Attachment 6 – Supplementary Material

The information in this Attachment 6 is referenced in the Council Report

6.3 – Summary of the recommended Changes to the DCP (post-exhibition)

6.5 – The Northern development site: with and without encroachment of the tower above the podium in the Parramatta Square Solar Access Plane (PSQ SAP) under the two options (Option A Parish Hall removed, and Option B parish hall partly retained)

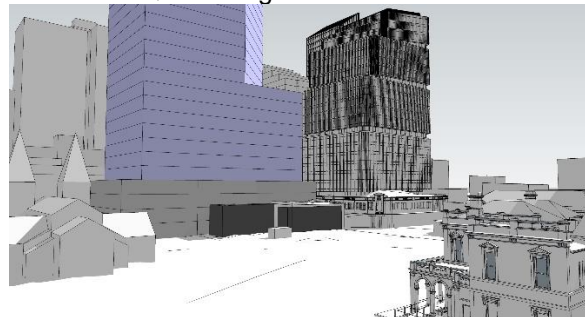
| Change | Reasoning |
|---|--|
| Include a new objective O.11 and a new control (C.8) under the heading 'Built Form' in both Option A and Option B, and amend the associated figure to require no development above the podium to encroach the PSQ SAP angle for the north-east corner of the Northern development site to reduce the mass and presence on the civic spaces and open up views across the podium to the street and sky. | In response to an issue raised by DPE in the study results for the Second CBD SEPP. |
